HISTORIC DISTRICT COMMISSION ADDITIONAL INFORMATION REQUEST

Application Number: HDC2026-00006

PROJECT ADDRESS: 1656 W. Boston Blvd.

HISTORIC DISTRICT: Boston-Edison

1656 W. Boston Blvd.
 Proposed enclosed porch + wood deck

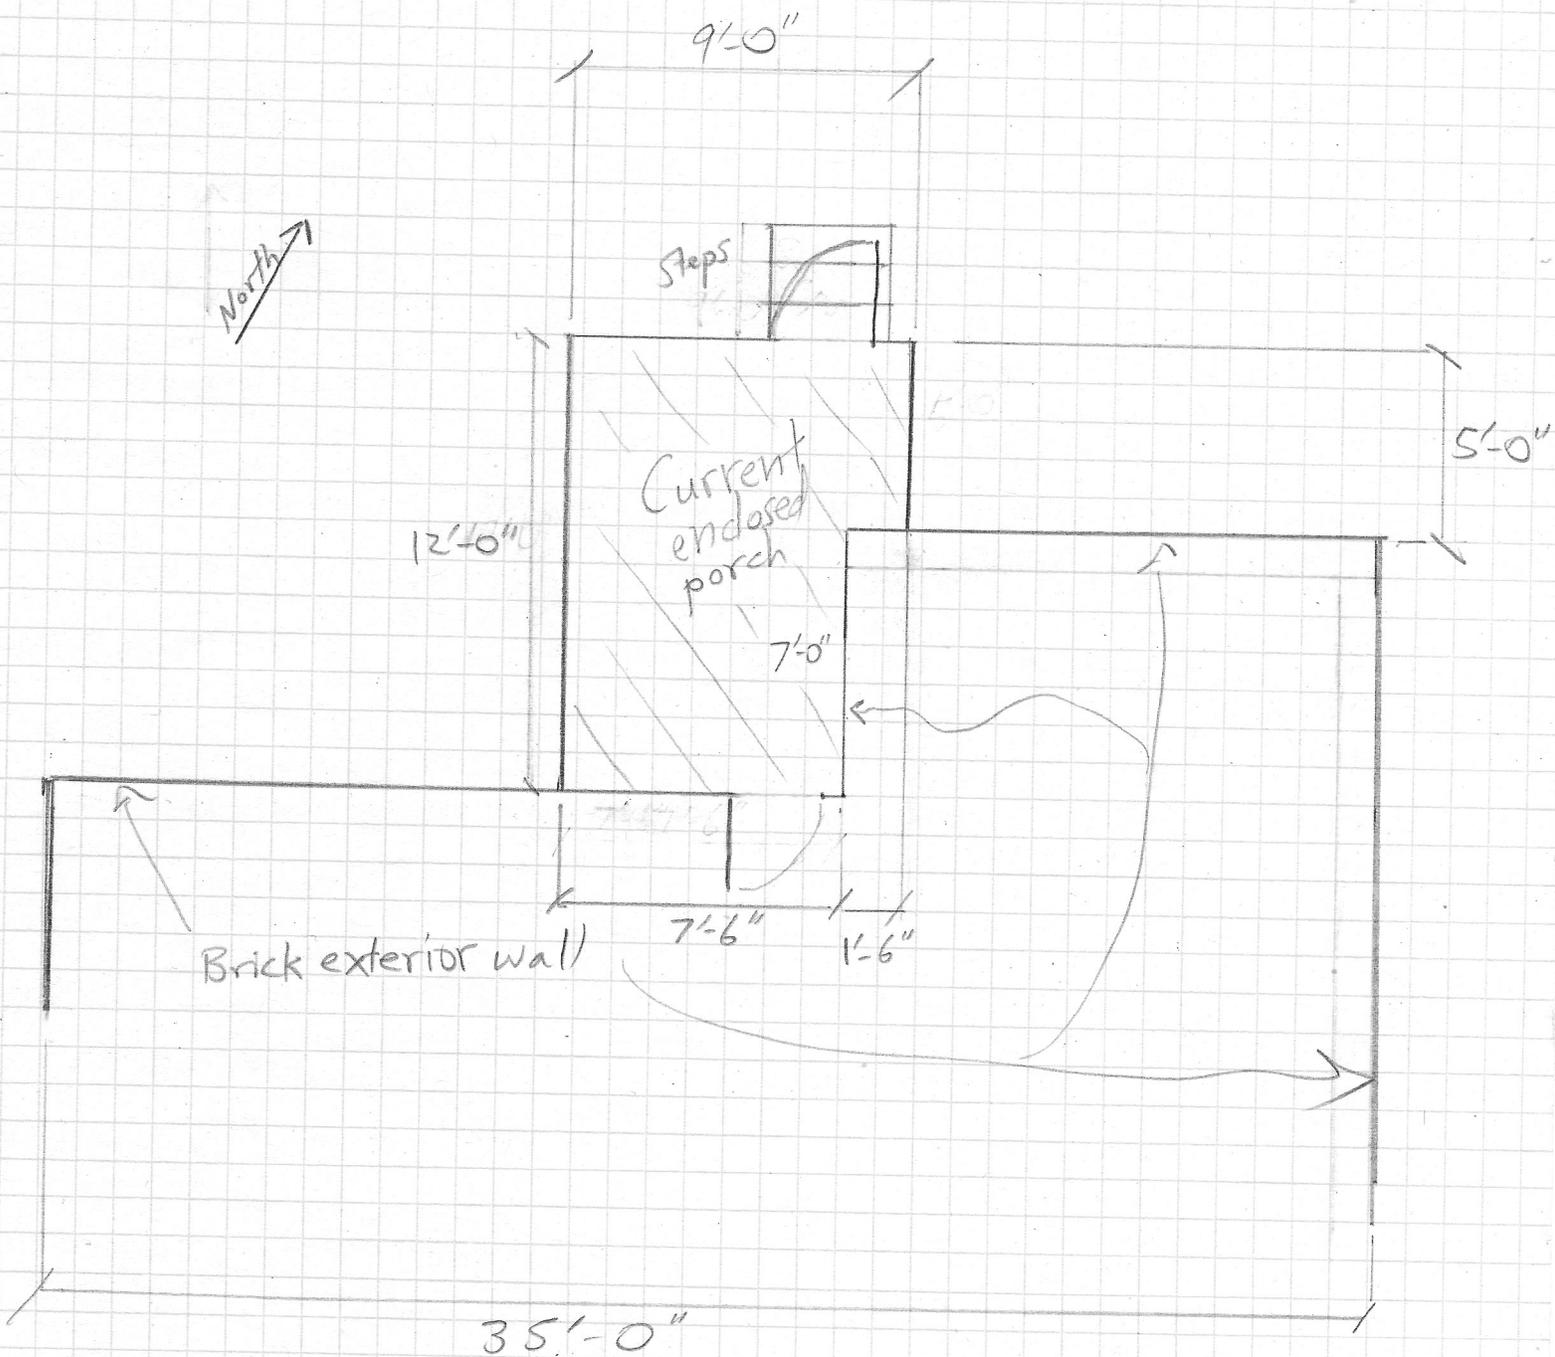
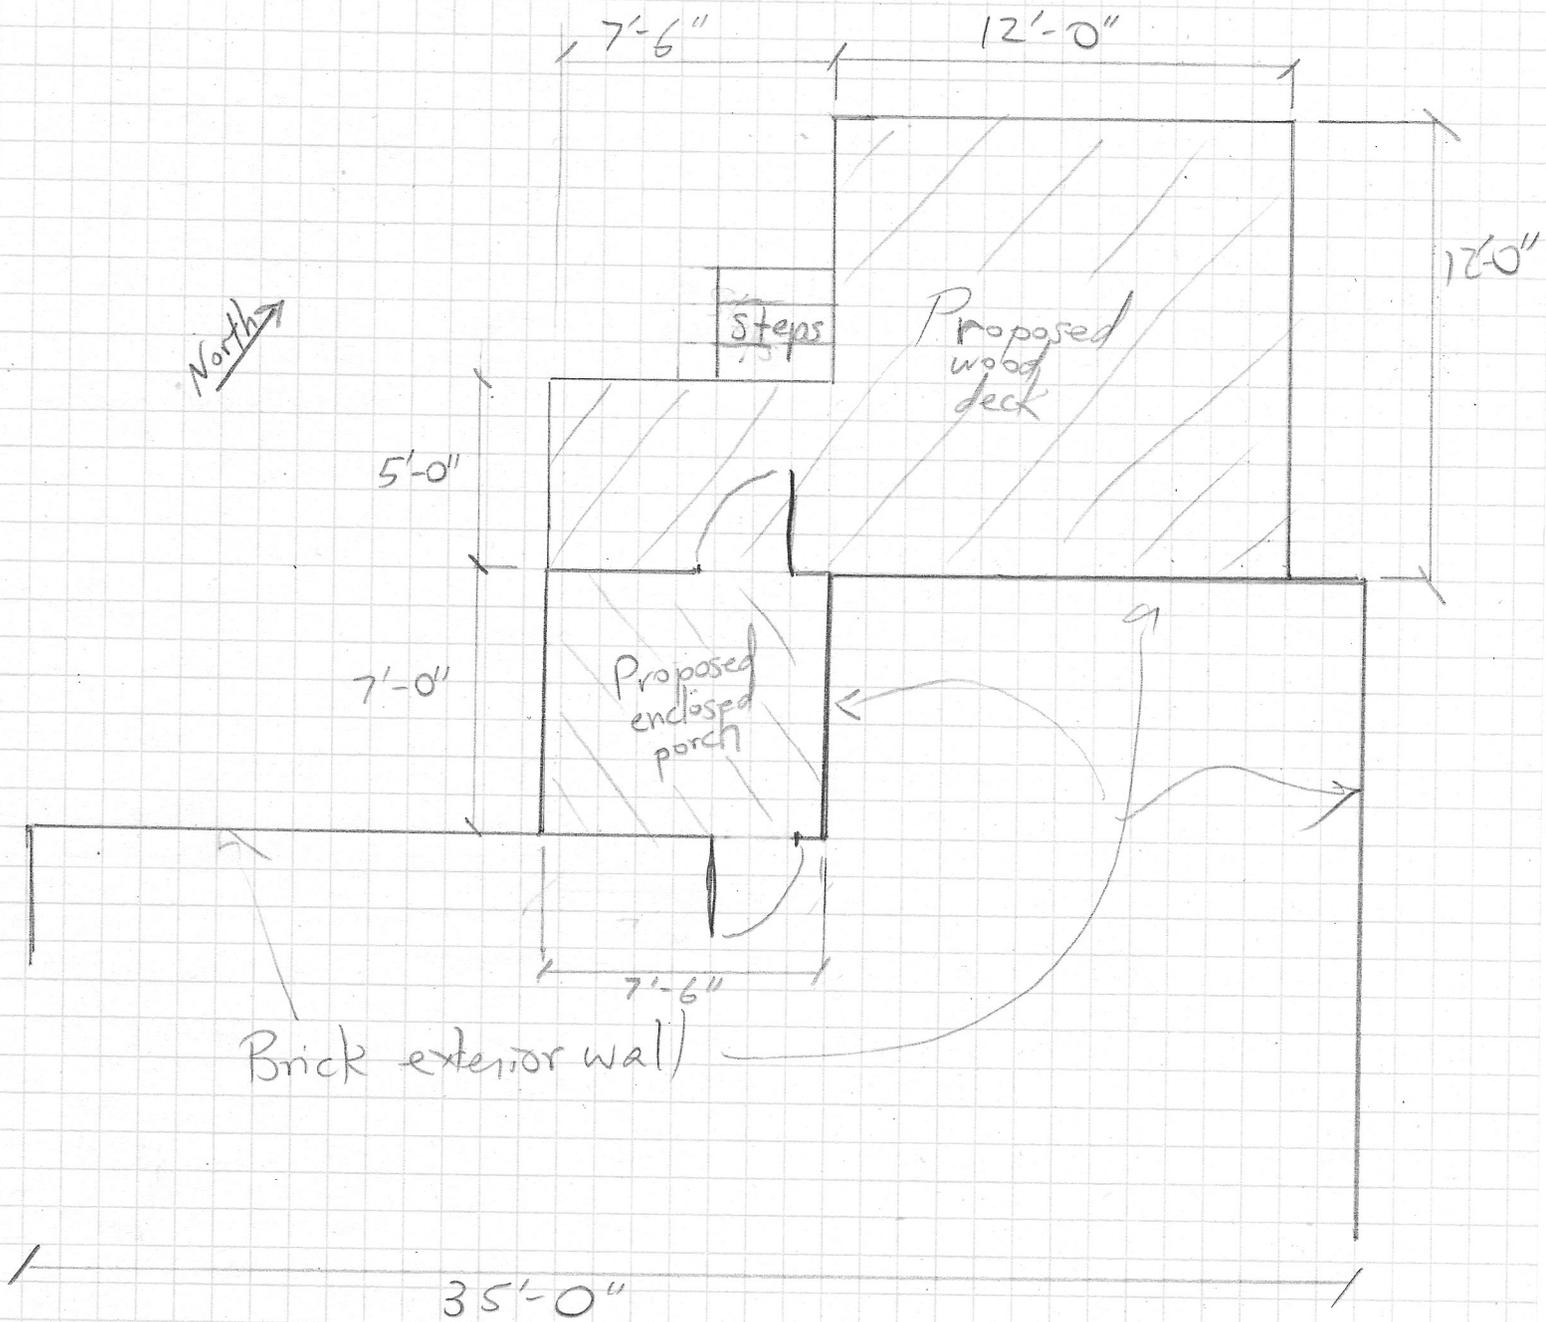
Staff has noted the following condition that must be identified in the revised drawings - the width of the existing rear enclosure extends across a portion of the masonry wall, therefore, the proposed enclosure will be narrower and less space will be between the door and window, correct?

For the deck, please identify the Trex components (square or round baluster kit for railing, railing color, decking color), and material specifications and dimensions of the stairs leading from the deck to the yard (also Trex?)

The existing roof and siding of the enclosed porch attached to the house will remain in place, so green wood siding and flat rubber sheet roofing with the existing pitch will be in place. The north face of the enclosed porch will be moved forward 5' to be flush with the north-facing rear brick wall at the northeast corner of the house. We propose also to reuse the existing porch door (36" wide) and window (48" wide) in this moved wall. It may be necessary to replace the window with something narrower. Apologies for not being more precise about this. The windows currently installed in the east and west walls of the enclosed porch will be eliminated. The east wall of the enclosure will be the brick wall of the house. The west wall will be solid green existing siding.

The deck material will be treated wood. The railings will be Trex aluminum square baluster, black. The steps are also treated wood, 7" high, 36" wide. Initially the wood will be unpainted or stained. We plan to stain it. If there are designated allowable colors we would appreciate knowing what those are.

Regarding the question about width of the proposed enclosed porch... yes, it will be reduced from 9'-0" to 7'-6" to account for the existing overlap over the corner of the house. This overlap will be eliminated

1656 W. Boston Blvd.
 Proposed deck/enclosed porch
 North elevation
 0.5cm = 1 foot

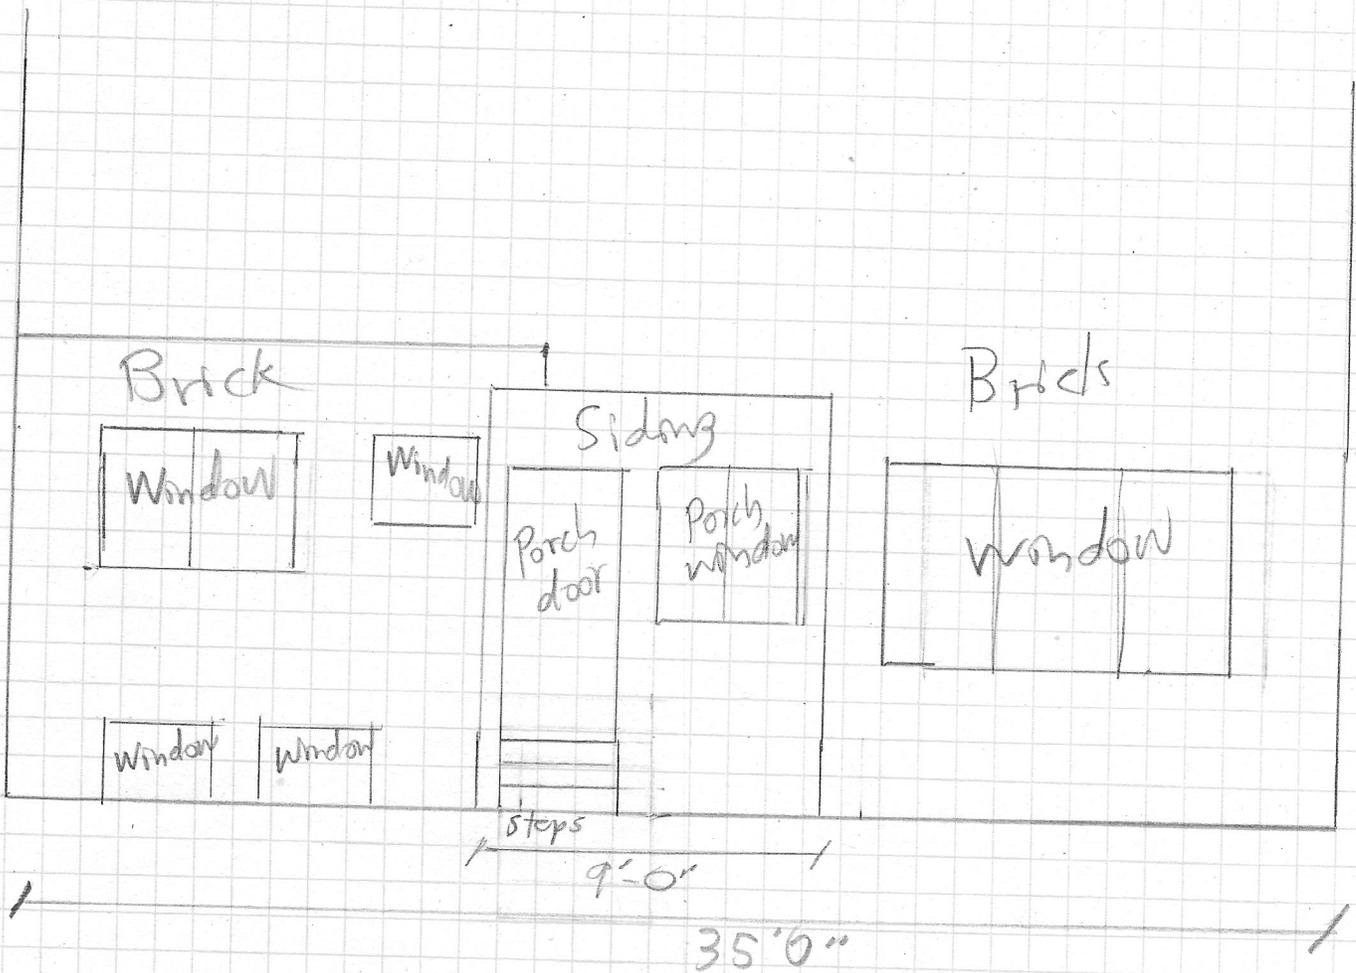
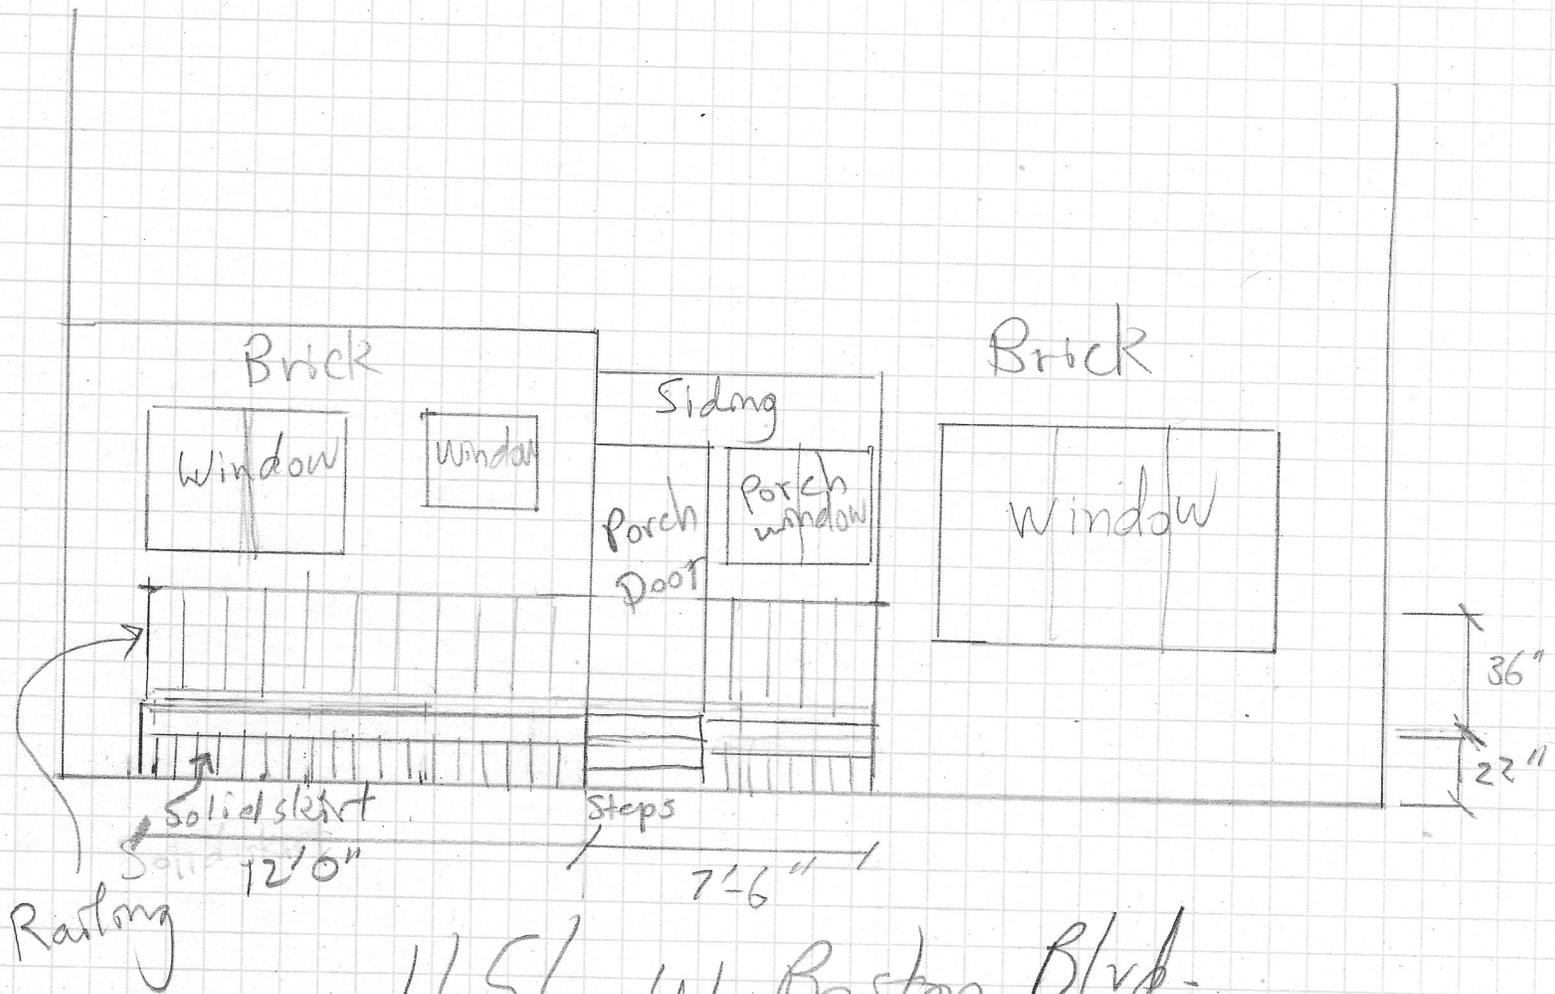
A detailed dimensioned floor plan and elevations are necessary. Hand drawn drawings are fine, but: 1) the elevations must include the level of detail as shown in the below elevation (which offers clarity on how the garage will look as it includes trim, exact placement of the door, roof material/pitch, etc.), and the floor plan must include not just the overall dimensions, but also dimensions of each opening and the spaces between them), AND 2) as your proposal is not a standalone building like this garage, the rear wall elevation (which you called "front") must include the full width of the rear of the house, so the Commission can see how the new enclosure will look and fit within the existing rear walls/window openings on the back of the house. Please also identify on the drawings how high up from the ground the windowsill will be installed, and list the lap siding material/finish/color, roof material, etc.

I realize I did not include the height of the porch window sill in the elevation. The sill is 58" above the concrete, 36" above the level of the deck and the porch floor.
